McMILLAN SAND FILTRATION SITE COMMUNITY CENTER & PARK DESIGN UPDATES

COMMISSION OF FINE ARTS SUBMISSION

4 MAY 2023

McMILLAN COMMUNITY CENTER LANDSCAPE DESIGN UPDATE

Figure 12: Updated site plan showing extents of bioretention

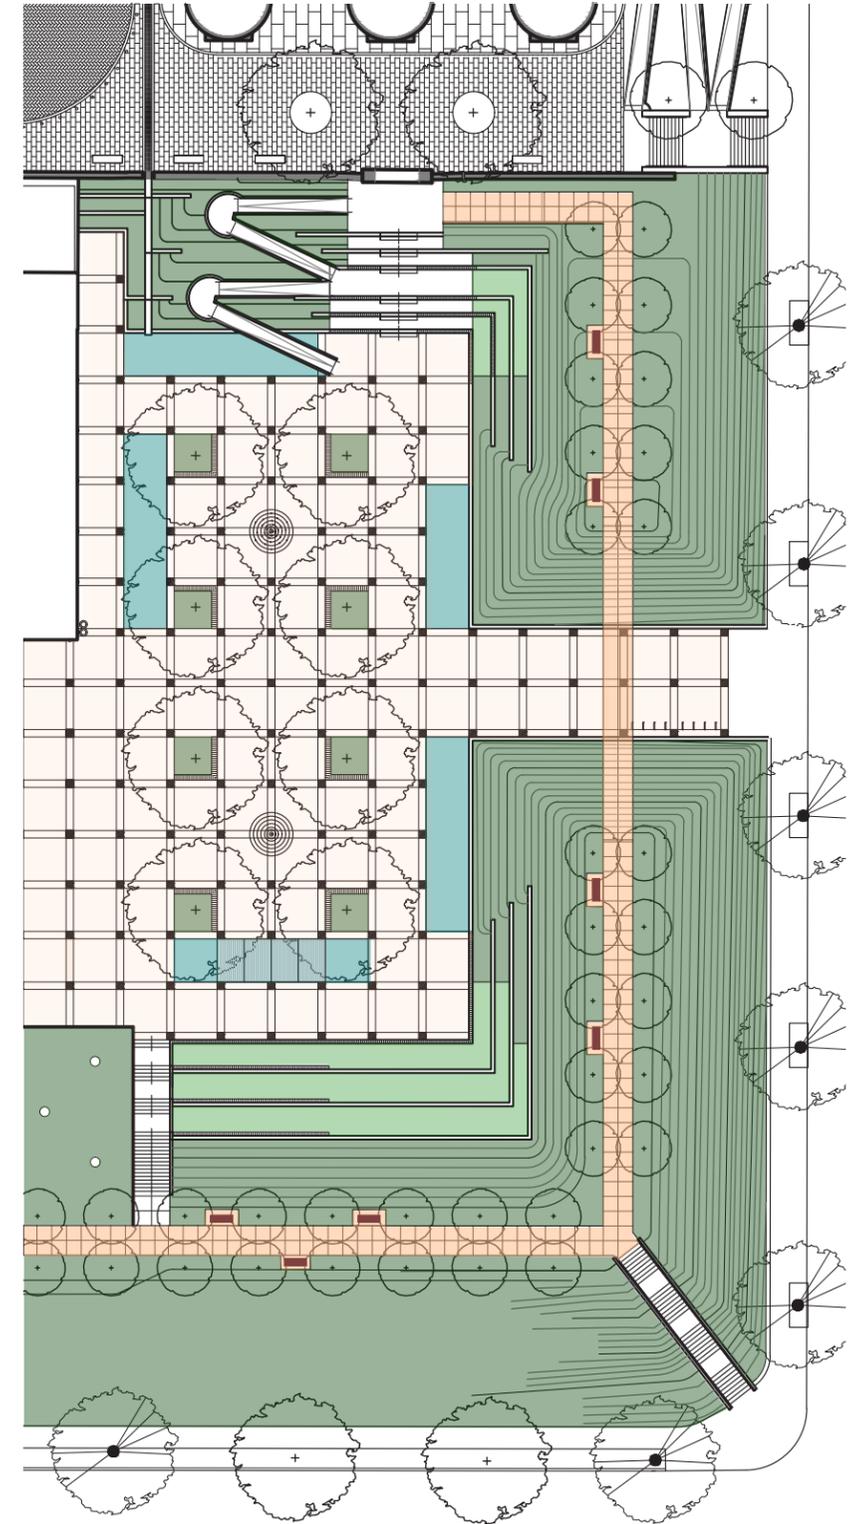
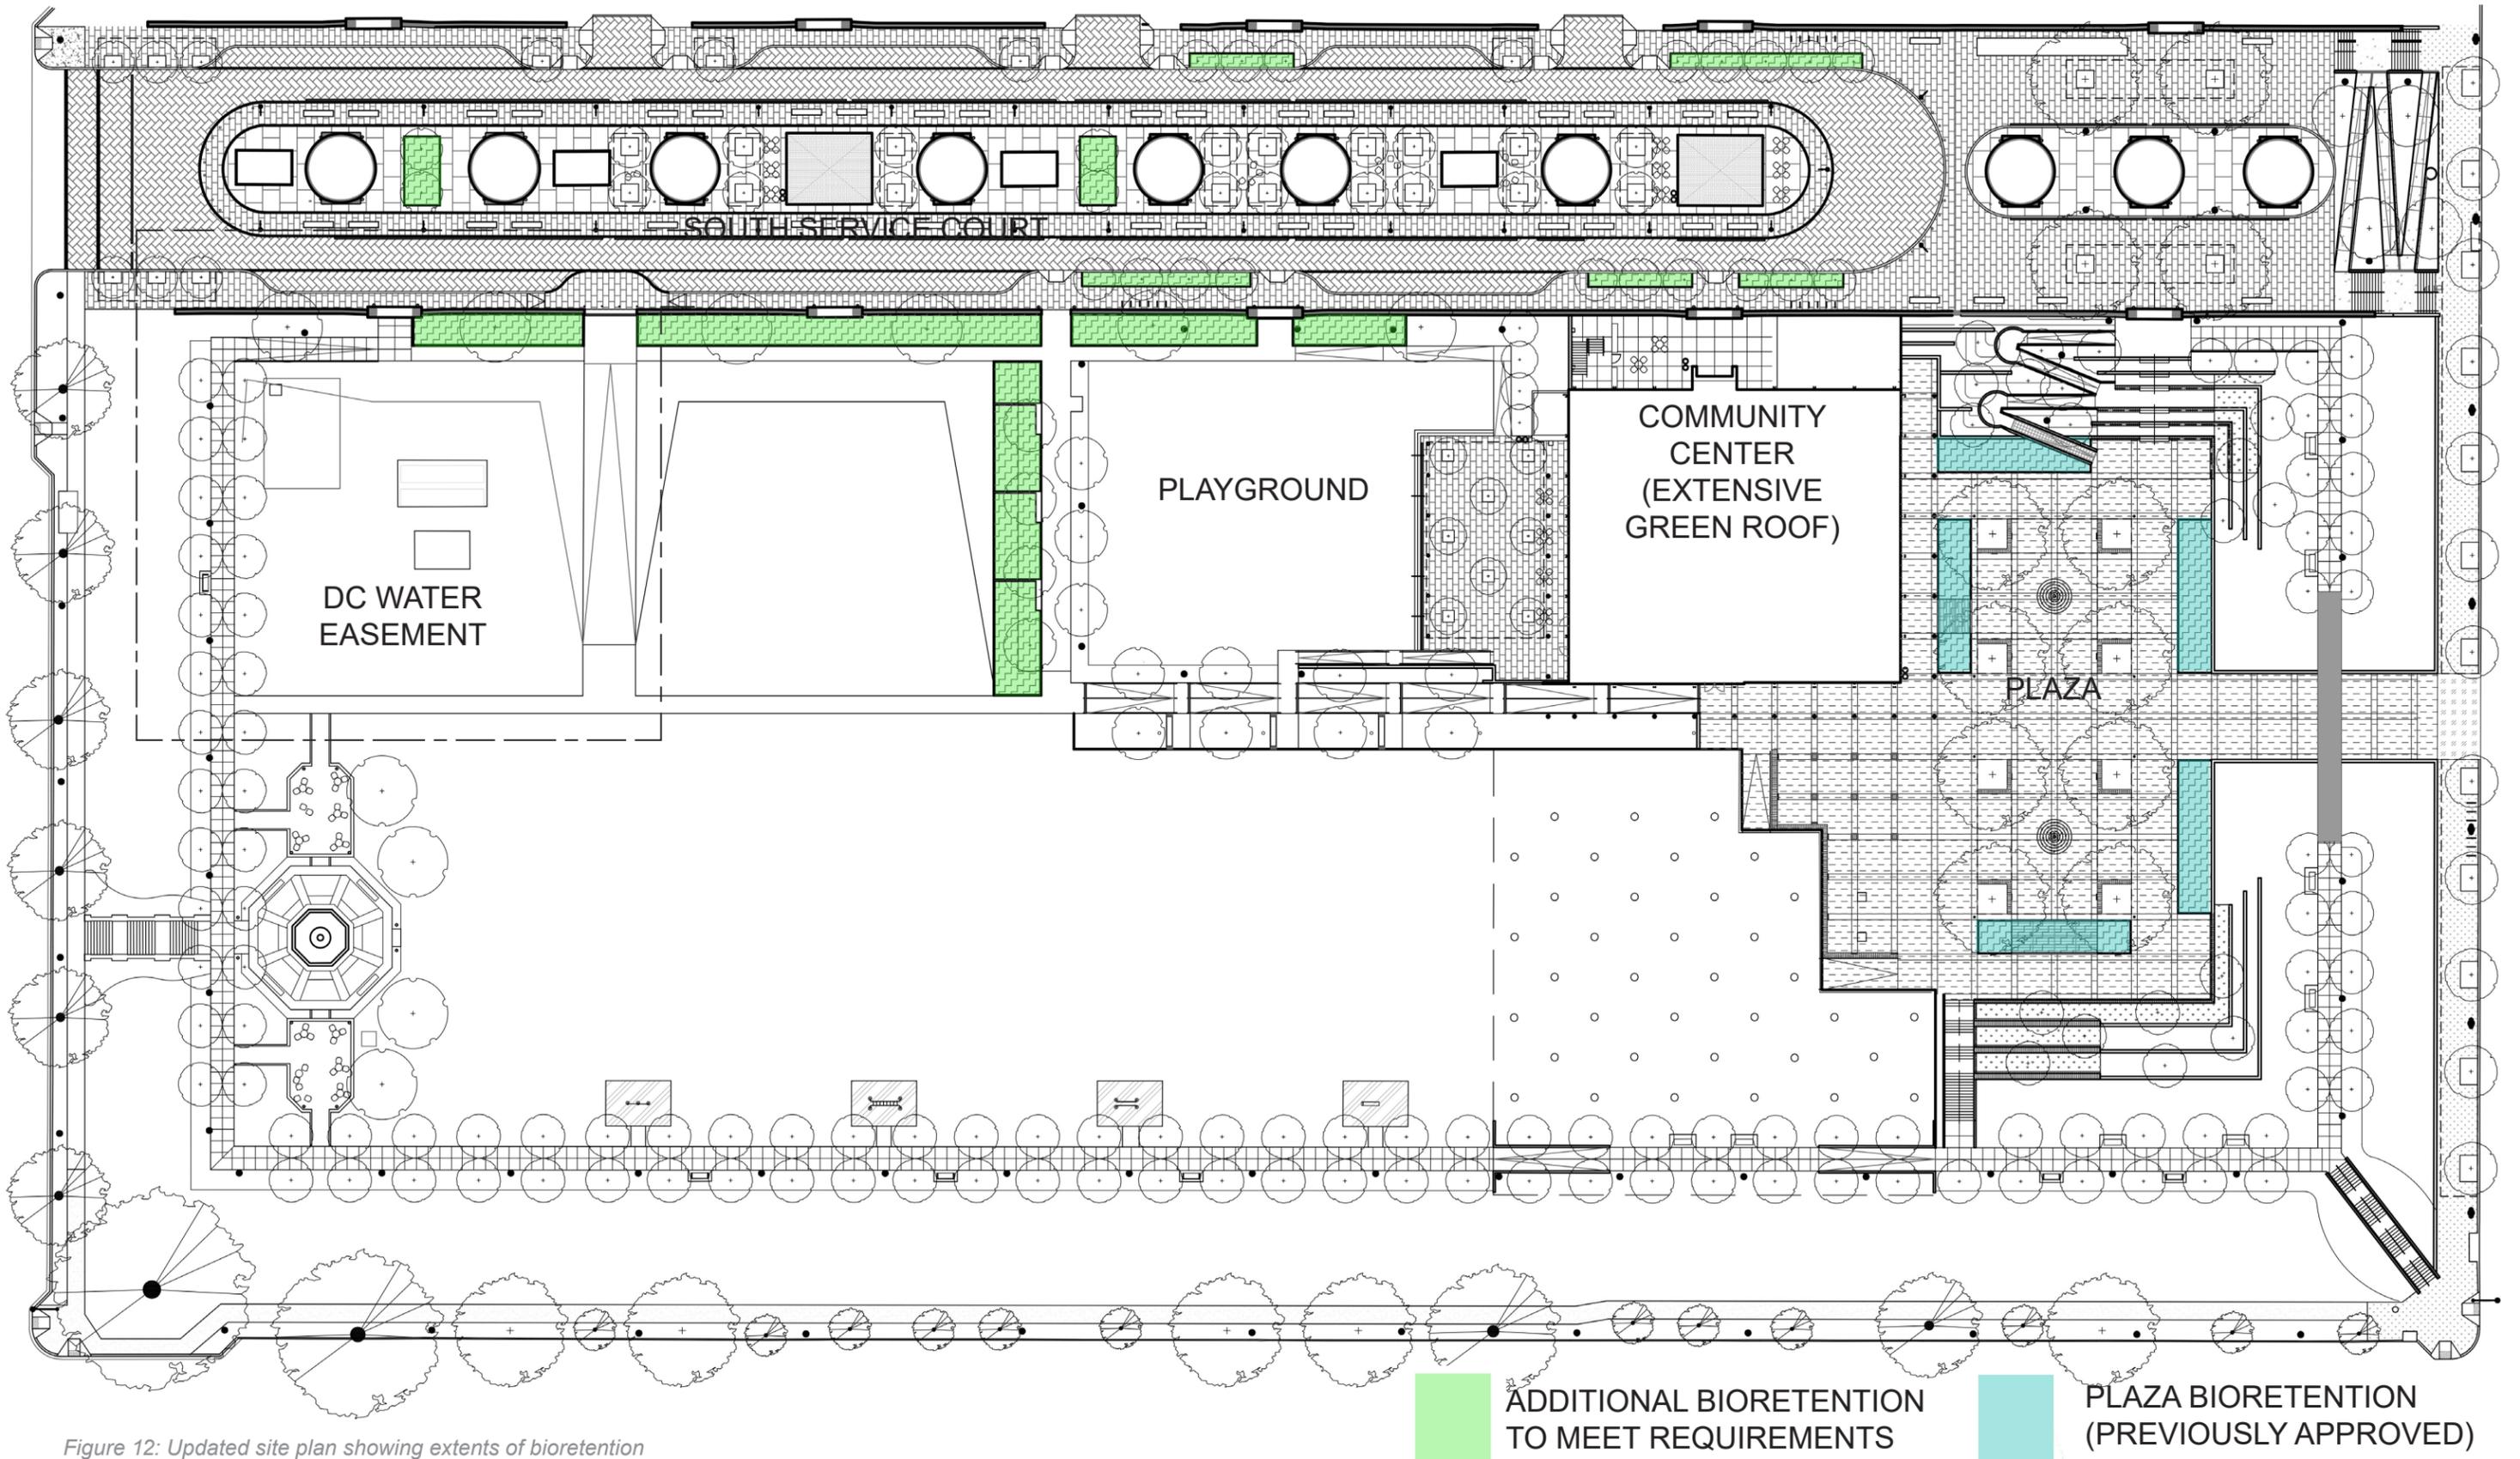
Previously approved plans showed bioretention basins in the plaza only, which were sized and laid-out to capture stormwater from the plaza itself and from a small segment of the South Service Court. The design approved by CFA Staff in December 2020 comprised 2,745 square feet of bioretention in the plaza. At that time, it was assumed that additional stormwater would be captured in an infiltration trench located to the west of the playground.

Geotechnical borings performed in 2021 demonstrated that existing subsoils were not appropriate for infiltration. In order to meet stormwater management requirements and to retain stormwater on-site, the design has been modified to increase bioretention.

As shown in Figure 12, some 5,780 square feet of bioretention has been added to the site to meet stormwater requirements. These bioretention areas have been sited in areas previously shown as either turf grass or shrub and perennial planting beds. For the most part, these will be concrete-lined basins located in either the South Service Court or at the base of the original South Service Court filter cell retaining wall. Along the west side of the playground where the lawn will slope down to the South Service Court filter cell retaining wall, a terraced bioretention feature will harness stormwater from the play field. Seating areas will be installed along the terraced bioretention basins. All basins will be bordered by knee-high guardrails and the ponding depth will be approximately 18 inches.
